# ADDENDUM

**Project:** Tri County Public Schools HVAC  
Renovation Phase V

**Project No.:** 23-003

**Addendum No.:** 1

M1.1

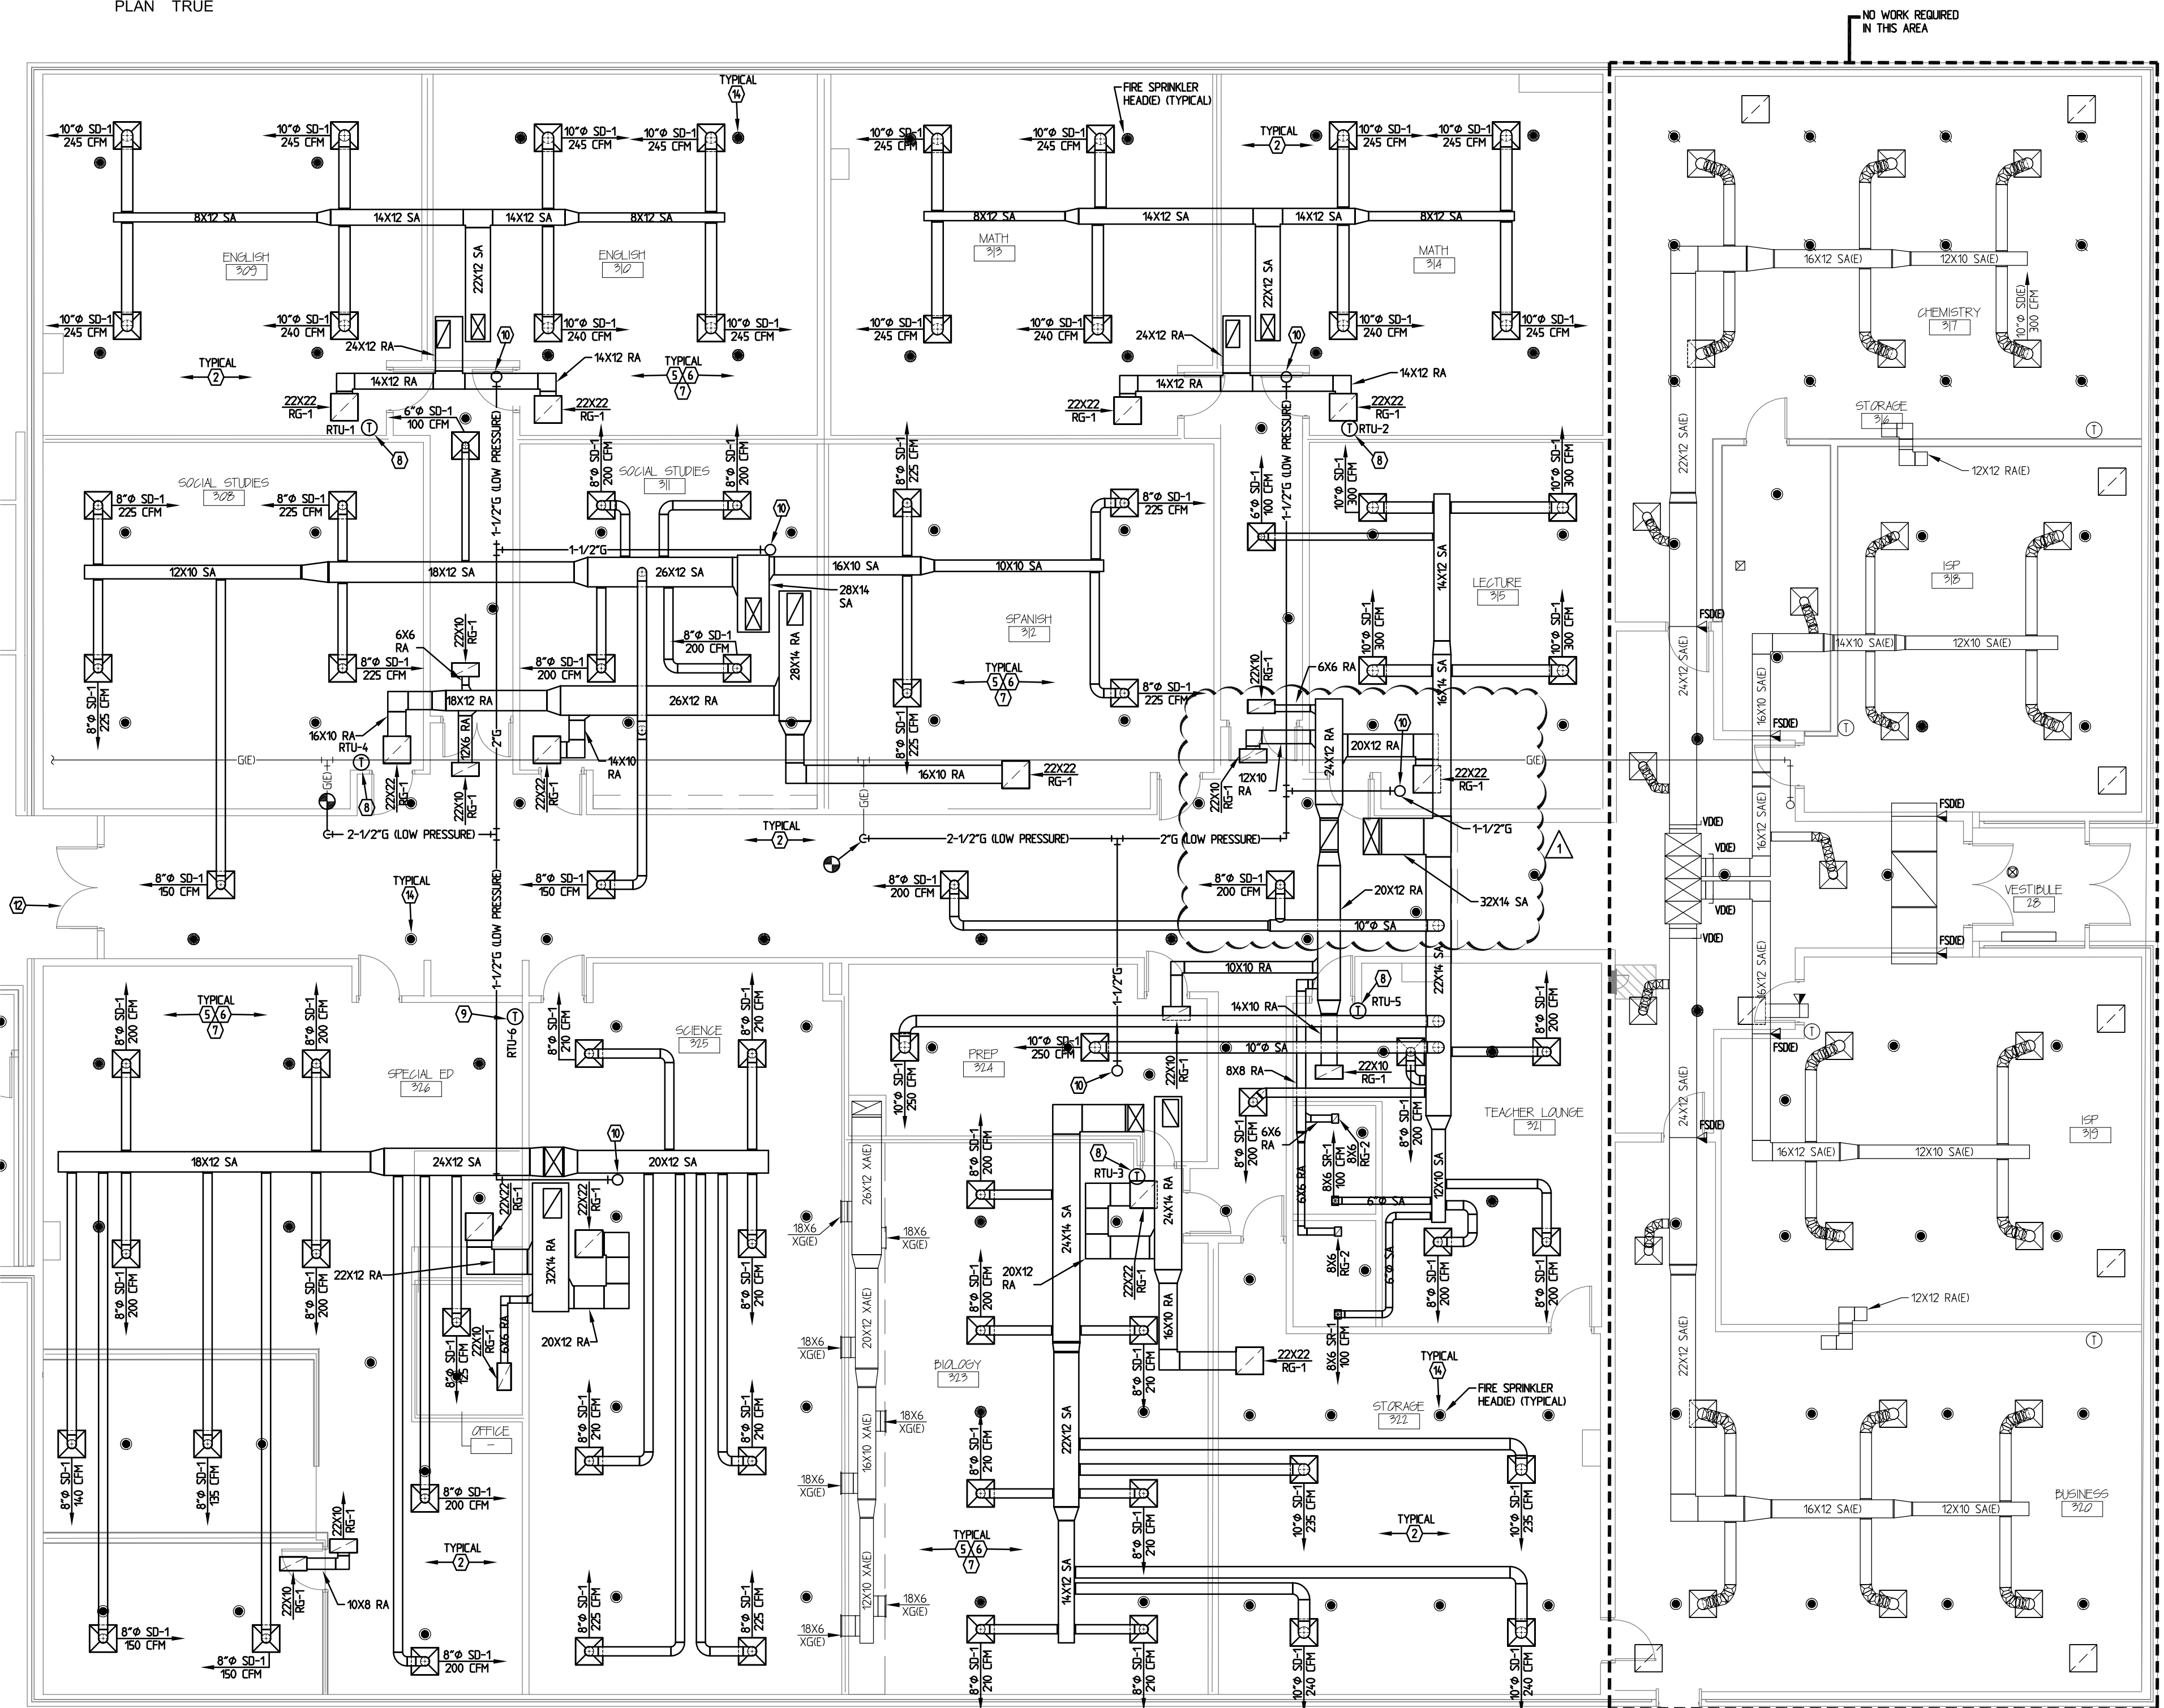
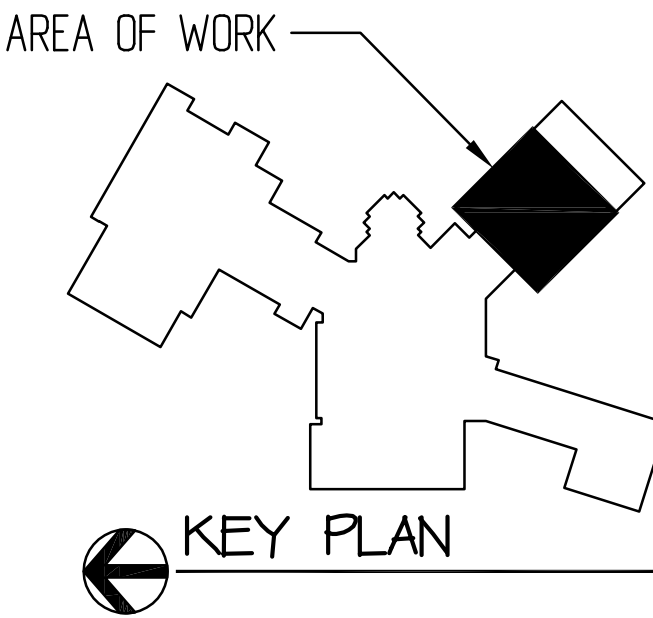
2. **M1.1 – Floor Plan – Mechanical** – see attached drawing.
  - a. Keynote 11 shall now read: Owner is replacing this portion of roof of Area 'C' as separate project. The roofing project will take place at the same time as this project. Scheduling of roof patching, roof top units, and roof top curb installation shall be coordinated with the roofer. Contractor shall coordinate all other related roof work with roofer throughout duration of project. Chapel Roofing is the contractor for the new roof, contact is Derrek Dagger 402-202-5750.

- b. Keynote 15 added: This area of roof is under warranty with Weathercraft. All roof patching, roof top unit installation, and roof curb installation shall be coordinated with Weathercraft. Contractor shall coordinate all other roof related work with Weathercraft for warranty work throughout duration of project. Weathercraft contact is Chris McClintock.

- c. Roof Plan – Mechanical
    - See revised drawing for area of roof that is still under warranty and area that is to be replaced under separate project during same time as this project.

- RTU-5 shall be shifted up on plan so it is located on portion of roof being replaced.
  - d. Floor Plan – Mechanical
    - Supply and return air ductwork and gas piping associated with RTU-5 reworked as required for new location of roof top unit.
